# BEAC PUBLIC HEARING

LOCAL ADOPTION OF THE LATEST  
CALIFORNIA BUILDING STANDARDS CODE  
AND UNIFORM HOUSING CODE

AUGUST 15, 2016

LBD DEVELOPMENT SERVICES

FIGURE 1809.3  
STEPPED FOOTING

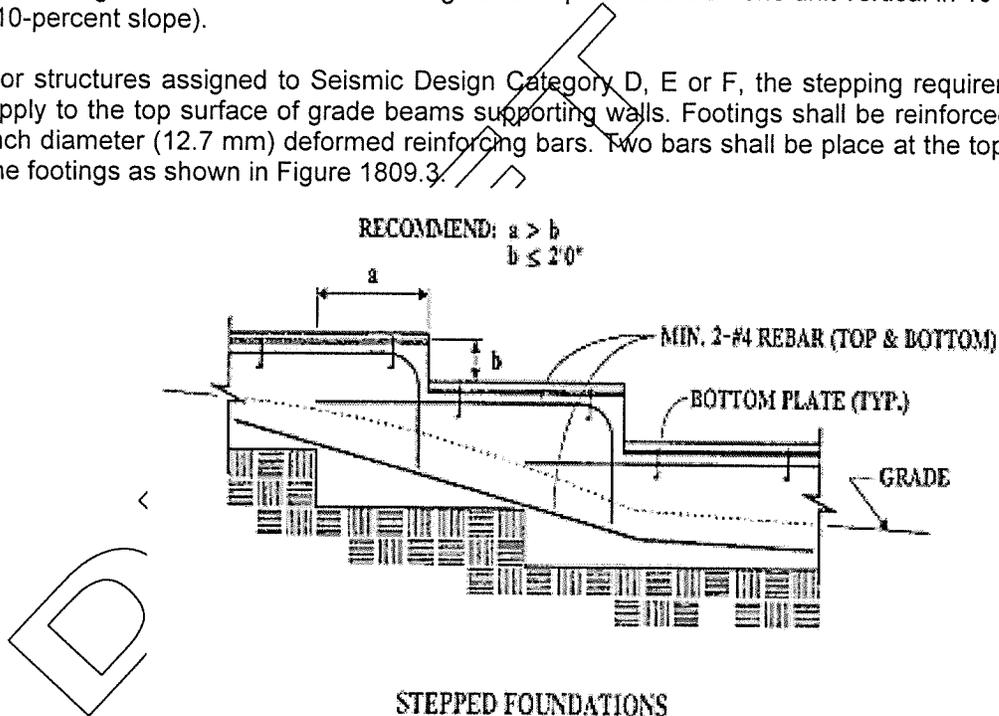
1809.3 Stepped footings. The top surface of footings shall be level. The bottom surface of footings shall be permitted to have a slope not exceeding one unit vertical in 10 units horizontal (10-percent slope). Footings shall be stepped where it is necessary to change the elevation of the top surface of the footing or where the surface of the ground slopes more than one unit vertical in 10 units horizontal (10-percent slope).

For structures assigned to Seismic Design Category D, E or F, the stepping requirement shall also apply to the top surface of grade beams supporting walls. Footings shall be reinforced with four 1/2-inch diameter (12.7 mm) deformed reinforcing bars. Two bars shall be placed at the top and bottom of the footings as shown in Figure 1809.3.
